CITY OF ALBUQUERQUE

**RE: Starbucks - Tramway
Grading and Drainage Plans
Engineer's Stamp Date: 06/12/23
Hydrology File: L23D015A**

Based upon the information provided in your submittal received 06/14/2023, the Grading & Drainage Plans **are not** approved for Building Permit, Grading Permit and for action by the Development Hearing Officer (DHO) on Preliminary/Final Plat. The following comments need to be addressed for approval of the above referenced project:

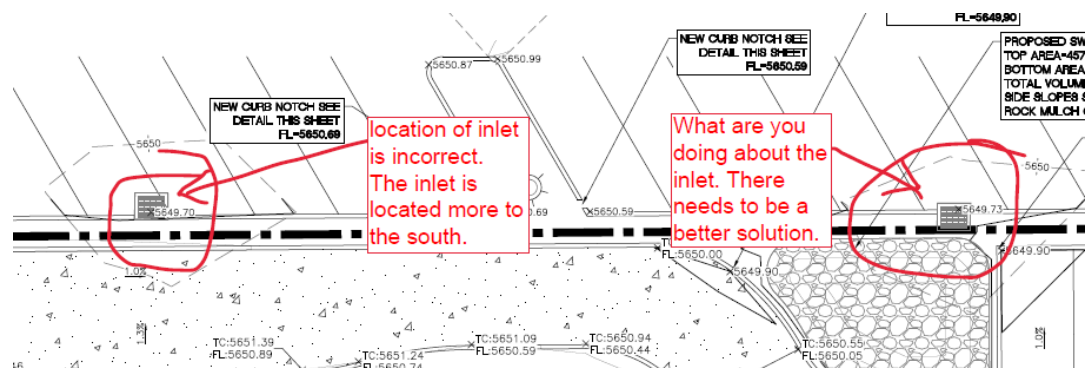
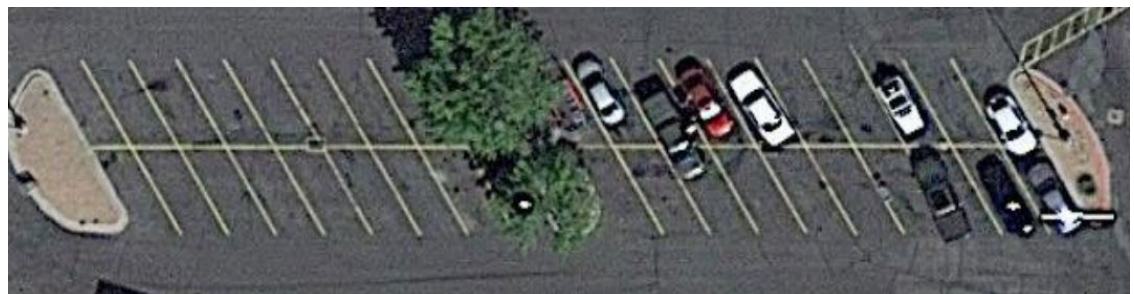
1. For the Existing Conditions, please show the whole drainage area for the existing two drainage inlets. This is Area B in the original Smith's plans. Please do a better solution to handling the placement of the existing inlets.

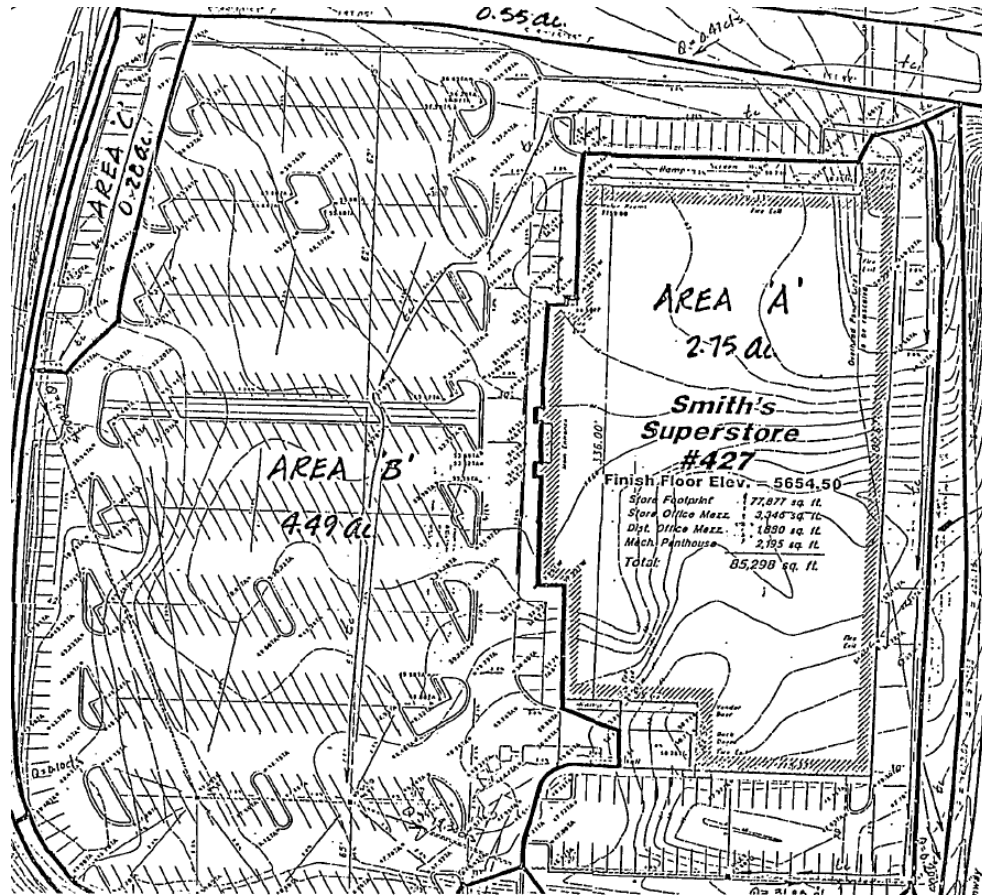
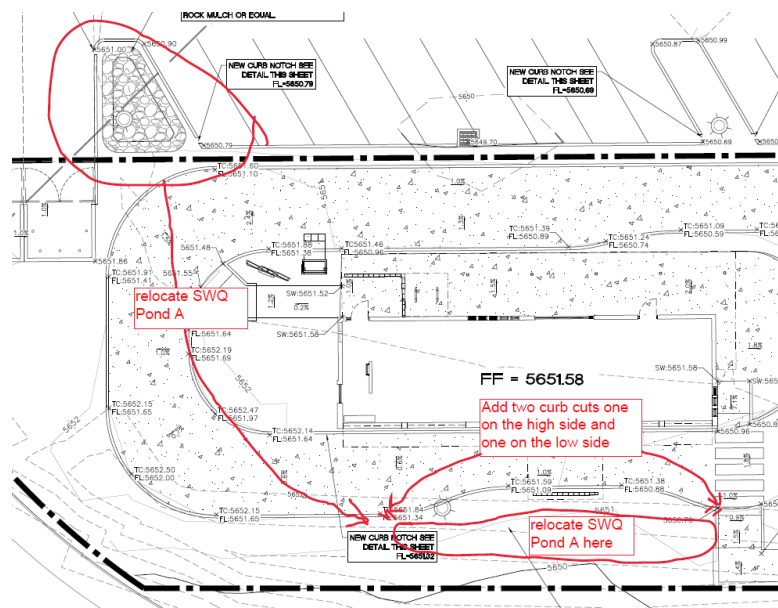
- SWQ Pond A does not get any drainage from this proposed development, therefore the pond needs to be relocated within the development and should get drainage.

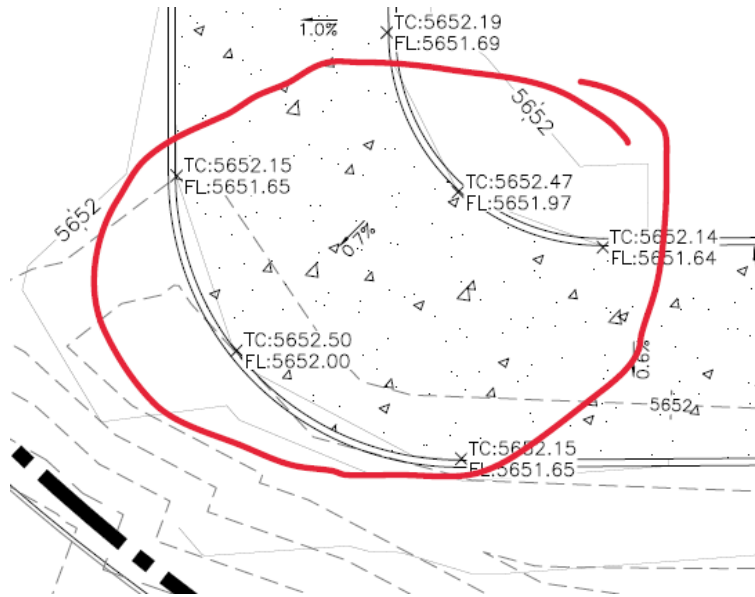
- Please adjust the grades. They do not currently flow the direction of the flow arrows. You have a flowline of 51.97 on the high side and a flowline of 52.00 on the low side.

- Please show the private storm sewer lines. The contractor will need to know where these are location so that they do not damage them during construction.
